**NEI 04-07**

**PRESSURIZED WATER REACTOR  
SUMP PERFORMANCE EVALUATION  
METHODOLOGY**

**Volume 2 – Safety Evaluation by the Office of Nuclear  
Reactor Regulation Related to NRC  
Generic Letter 2004-02, Revision 0,  
December 6, 2004**

**SAFETY EVALUATION BY**  
**THE OFFICE OF NUCLEAR REACTOR REGULATION**  
**RELATED TO NRC GENERIC LETTER 2004-02,**  
**NUCLEAR ENERGY INSTITUTE**  
**GUIDANCE REPORT**  
**(PROPOSED DOCUMENT NUMBER NEI 04-07),**  
**“PRESSURIZED WATER REACTOR**  
**SUMP PERFORMANCE EVALUATION METHODOLOGY”**

**Figure 3-1. Comparison of GR Isobar Map (Blue) with Isobars from Independently Evaluated ANSI Jet Model (Red)**

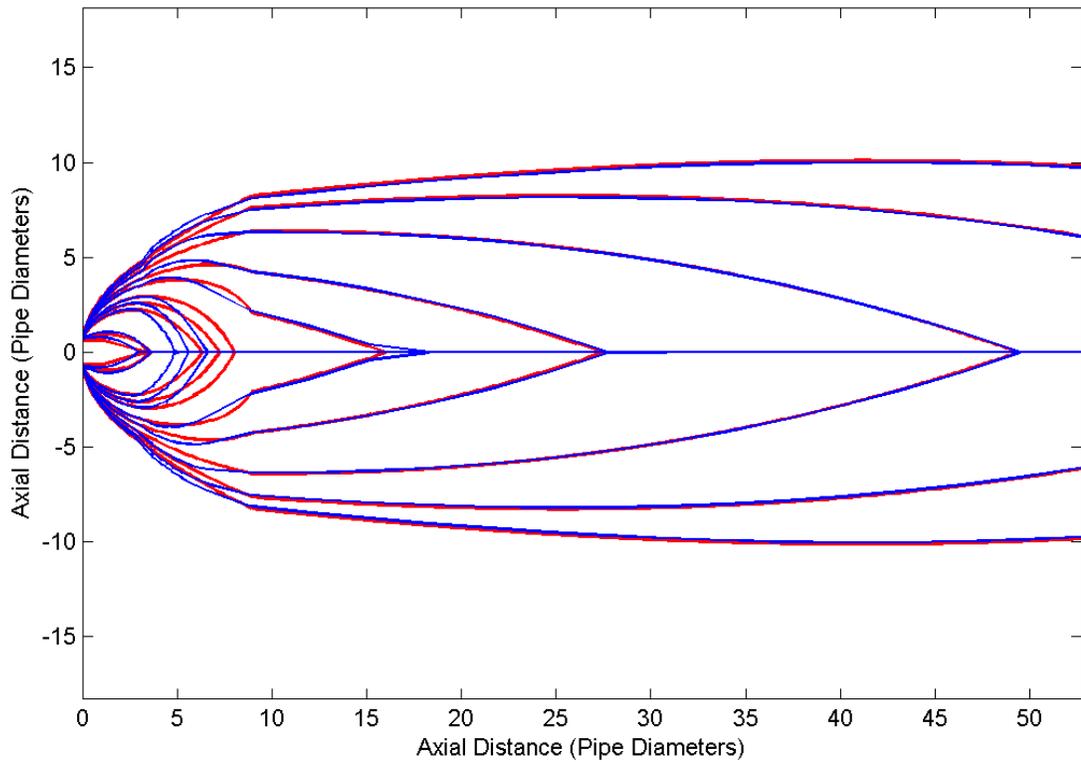
Good agreement is seen between the calculations for downrange behavior (Zone 3), but discrepancies exist in Zones 1 and 2. It appears that contour termination points on the centerline are not accurate and that the quadratic behavior of the Zone 2 isobar equations is not implemented correctly. These differences will have a negligible effect on volume integrals for jet pressures less than 20 psig, but may become more of a concern for higher pressures near the break. To quantify the magnitude of the difference, Table 3-1 below presents a comparison of ZOI radii computed from both methods. In particular, the GR approach may not have preserved the system stagnation pressure throughout the volume of the liquid core region, as specified by the standard. However, the GR recommended values essentially bound both sets of calculated values.

**Figure I-1. ANSI Jet-Model Stagnation Pressures for PWR Cold-Leg Break Conditions (530 °F, 2250 psia)**

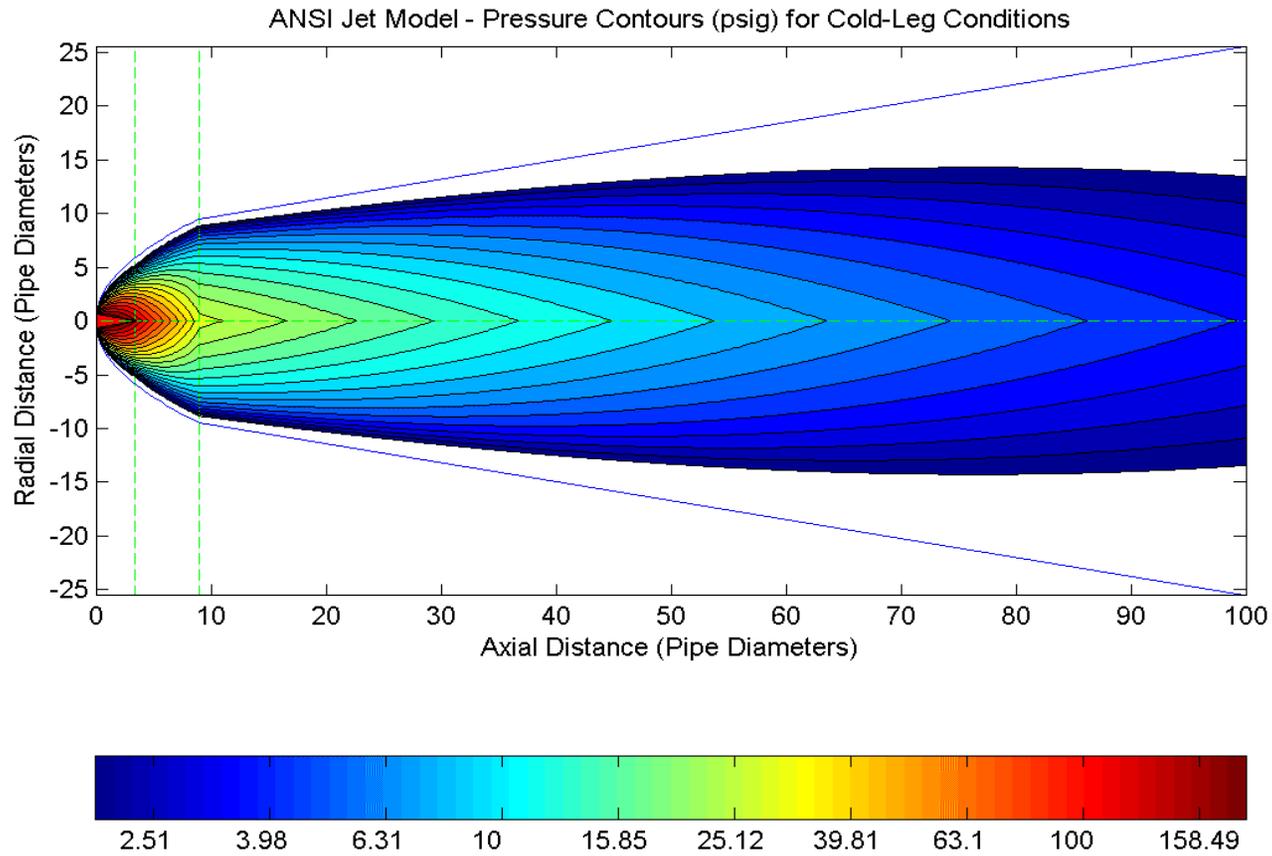
boundary of the core. Equation (I-20) provides no similar constraint, so there will be a sharp discontinuity in pressure at the boundary of the jet core when this condition is invoked, as shown in Figure I-1. Equations (I-19) and (I-20) were not intended to be evaluated inside of the core region. Within the core, the system stagnation conditions are presumed to hold.

The sharp tip of each contour shown in Figure I-1 is another nonphysical feature of the ANSI model that arises from a lack of attention to matching spatial first derivatives. It might be expected that each isobar is smoothly bounded and has infinite slope at the terminal point, especially at very low pressures where the jet returns to ambient conditions. It is helpful to know the distance to the terminal point of each contour for iterative integration of spatial volumes. These points can be found by solving the centerline pressure equations (I-21) and (I-23) for distances  $L_t$  corresponding to the desired pressure. Note that Zone 1 has no terminal points except for the jet core.

- A discontinuity in the slope of the isobars exists between Zones 2 and 3. Figure I-1 clearly shows this discontinuity. The sharp terminal points of pressure isobars at the axial centerline also suggest that more attention could be given to the behavior of first spatial derivatives.
